City of El Paso – City Plan Commission Staff Report

2nd REVISED

Case No: SUSU15-00084 Charter School Solutions
Application Type: Resubdivision Combination
CPC Hearing Date: February 11, 2016
Staff Planner: Armida Martinez, (915) 212-1605, martinezar@elpasotexas.gov
Location: North of Betel and West of Americas
Acreage: 10.667
Rep District: 6
Existing Use: Vacant
Existing Zoning: A-2 (Apartments)
Proposed Zoning: A-2 (Apartments)
Nearest Park: Feather Lake (.58 miles)
Nearest School: Harmony Science Academy (K-12) Charter (next door)
Park Fees Required: N/A
Impact Fee Area: N/A
Property Owner: Charter School Solutions
Applicant: Charter School Solutions
Representative: Etzold & Co

ATTACHMENT 3

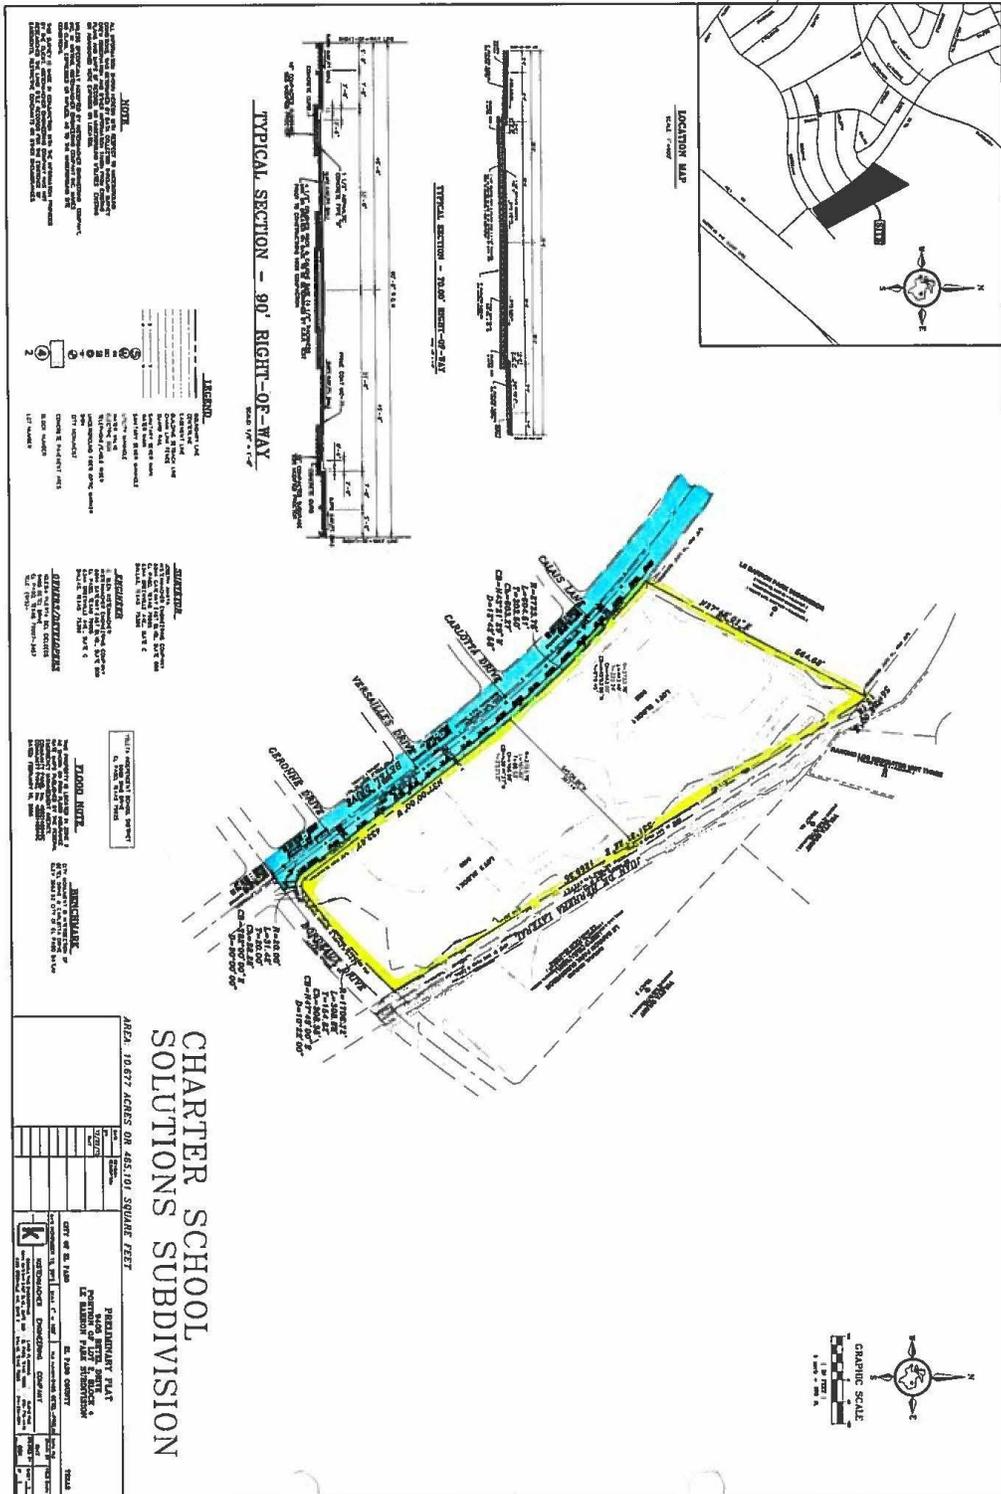
1. Scale typical street cross section for 70’ ROW to match the scale of the 90’ ROW for legibility on preliminary plat.
2. Remove the pavement thickness values on both typical cross sections.
3. Add note to final plat sheet: “The retention of the difference between Historic and Developed Storm-water runoff discharge volumes shall be retained within subdivision limits (DSC, 19.19.010A and DDM, 11.1). Historic storm water runoff rates must not be exceeded. Ensure historic runoff volume, peak, and duration are maintained.

3. Revise cross section for Bordeaux Street to reflect a 5ft. sidewalk.
4. Provide reason for the replat.
5. Identify appropriate school district on final plat.

6. Verify statement 7 under “Notes” on the final plat.
7. Provide acreage and square footage of each lot.
8. Verify owner in the dedication statement.
9. Verify Lot boundary dimensions

10. Indicate if any proposed easements are being dedicated, as well as any existing easements.
11. Verify dedication statement.
12. Provide drainage arrows on the preliminary plat.
